**SUBJECT: Rear Auxiliary Lamp Compliance**  
**MODEL YEARS: 2024 & Beyond**  
**AFFECTED MODELS: UU Model THREE**  
**INITIATION DATE: 11/16/2023**  
**REVISION: 11/28/2023**

Fig 1

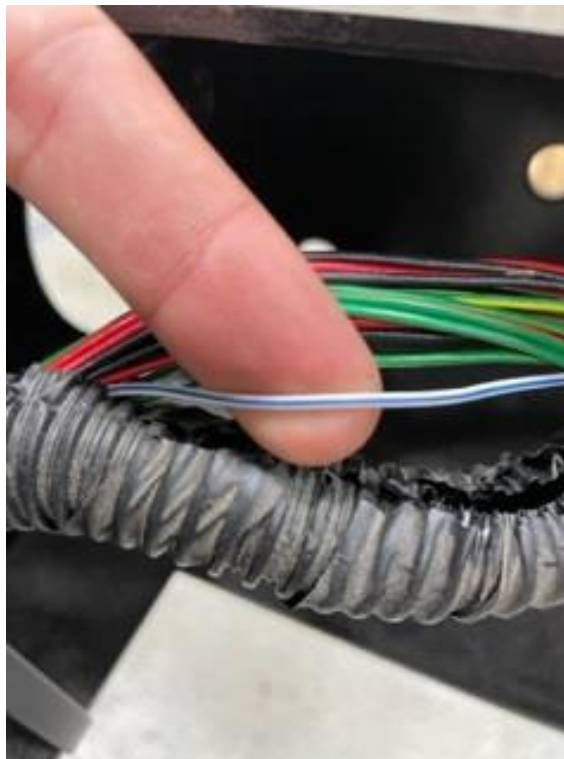
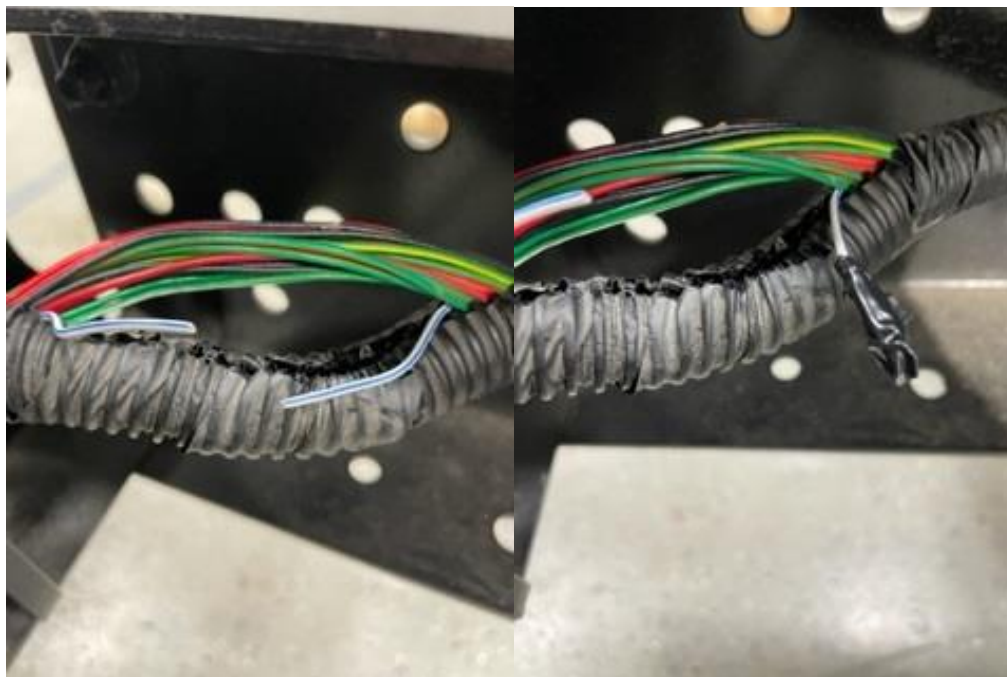
**Description of Concern:** The current Turn Signal / Headlamp stalk on the left side of the steering column offers a twist switch to enable for a Front or Rear Fog Lamp feature. The second detent enables the Rear Fog Lamp feature and Cluster Symbol (see Fig 1 & 2). Federal regulation (FMVSS) compliance prohibits the use of Rear Fog Lamps on DOT approved vehicles. This feature should not be enabled on the completed vehicle upfit.

Above Lamp Stalk switch for Rear Fog Lamps (left) and Instrument Cluster Symbol (right)

**Solution:** Federal regulations (FMVSS) prohibit the use of Rear Fog Lamp feature regardless of the applied tail lamp units. The Second Stage Manufacturer (Upfitter) is responsible to certify their completed vehicle meets all local, state, and federal FMVSS requirements. The Upfitter should use the following tail lamp wiring instructions for disabling the Rear Fog Lamp feature.

- 1) Above aft frame location where Rear Fog Lamp harness wire can be disabled. Open the plastic wire loom in this area and find the white/blue wire.

- 2) Above snip the white/blue wire, tape or heat shrink the forward most 'hot' side end. Reinstall all wires back in the plastic loom, use electrical tape to seal the loom.

Above reference the Rear Fog Lamp connector location in both OEM Rear Tail Lamps. The #2 pin connector hosts the white/blue stripe rear fog lamp wire. This connection must be disabled.

Once above Steps 1 & 2 are completed its important to note this procedure will not eliminate the stalk switch function. The switch when activated will still cue the instrument cluster symbol. However, the Rear Fog Lamp feature will be disabled for FMVSS compliance.
